<b>Office Action Summary</b>	<b>Application No.</b> 10/733,226	<b>Applicant(s)</b> HIATT ET AL.	
	<b>Examiner</b> Colleen A. Matthews	<b>Art Unit</b> 2811

### **DETAILED ACTION**

***Kim's Figure 4, Annotated***

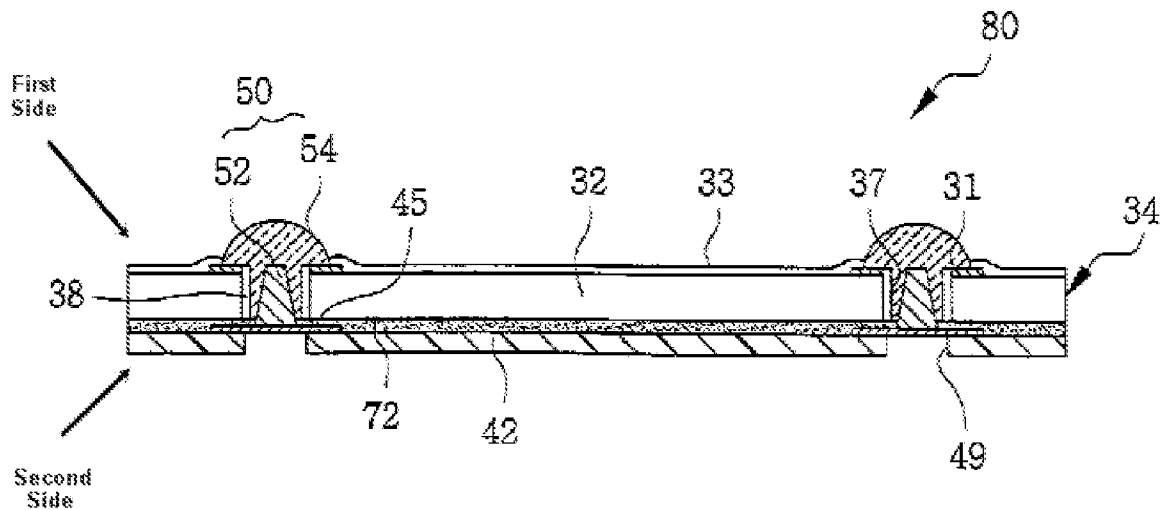
**Re claim 28:** Kim closes a packaged microelectronic device (Figures 4 and 17, for example) comprising:

a die (30) having a first side (see First Side, *Kim's Figure 4, Annotated*) and a second side (see Second Side, *Kim's Figure 4, Annotated*) opposite to the first side, the die further having

an integrated circuit (34) positioned between the first and second sides;

a bond-pad (31) positioned on the first side of the die and electrically coupled to the integrated circuit;

a passage (37) extending completely through the die and aligned with and extending through the bond-pad (also see Fig 14);

a first conductive material (54) deposited in a first portion of the passage adjacent to the first side of the die to form a conductive plug electrically connected to the bond-pad; and

a second conductive material (52) deposited in a second portion of the passage in contact with the conductive plug to at least generally fill the passage from the conductive plug to the second side of the die.

**Re claim 33:** Klm discloses a microfeature workpiece (Figures 4 and 17, for example) having a first side and a second side opposite to the first side, the microfeature workpiece comprising:

- at least one die (30);

- a bond-pad (31) formed on the first side of the microfeature workpiece;

- a passage (37) extending completely through the bond-pad and the die from the first side of the microfeature workpiece to the second side of the microfeature workpiece;

- a first conductive material (54) deposited in a first portion of the passage adjacent to the first side of the microfeature workpiece to form a conductive plug in contact with the bond-pad; and

- a second conductive material (52) deposited in a second portion of the passage in contact with the conductive plug to at least generally fill the passage from the conductive plug to the second side of the microfeature workpiece, wherein the first conductive material (solder, col 4 lines 38-39) is different than the second conductive material (metal bump, for example copper, col 4 line 36 and col 7 line 25-33).

a first die (30) with a first integrated circuit (34) and a first bond-pad (37) electrically coupled to the first integrated circuit, the first die further including a passage (37) extending completely through the first die and the first bond-pad (see Fig 14); and

a conductive interconnect (50) deposited in the passage, the conductive interconnect including a first conductive material (54) deposited in a first portion of the passage to form a conductive plug having a boundary in the passage, and a second conductive material (52) deposited in a second portion of the passage in contact with the boundary of the conductive plug to at least generally fill the passage; and

a first die (30) with a first integrated circuit (34) and a first bond-pad (31) electrically coupled to the first integrated circuit, the first die further including a passage (37) aligned with and extending through the first bond-pad (see Fig 14); and

a conductive interconnect (50) deposited in the passage, the conductive interconnect including a first conductive material (54) deposited in a first portion of the passage to form a conductive plug in contact with the bond-pad (see Fig 14), and a second conductive material (52) deposited in a second portion of the passage in contact with the conductive plug to at least generally fill the passage; and

**Re claims 29 and 36:** Kim discloses packaged microelectronic device of claims 28 and 33 as above. Kim further teaches an insulative layer (38) deposited in the passage between the die and the first and second conductive materials (col 4 lines 31-33).

**Re claims 49-52:** Kim discloses the packaged microelectronic device of claims 28, 33, 39 and 44 further comprising an insulative layer (38/72) deposited in the passage (37), wherein the second conductive material (52) contacts the conductive plug (54) and the insulative layer.
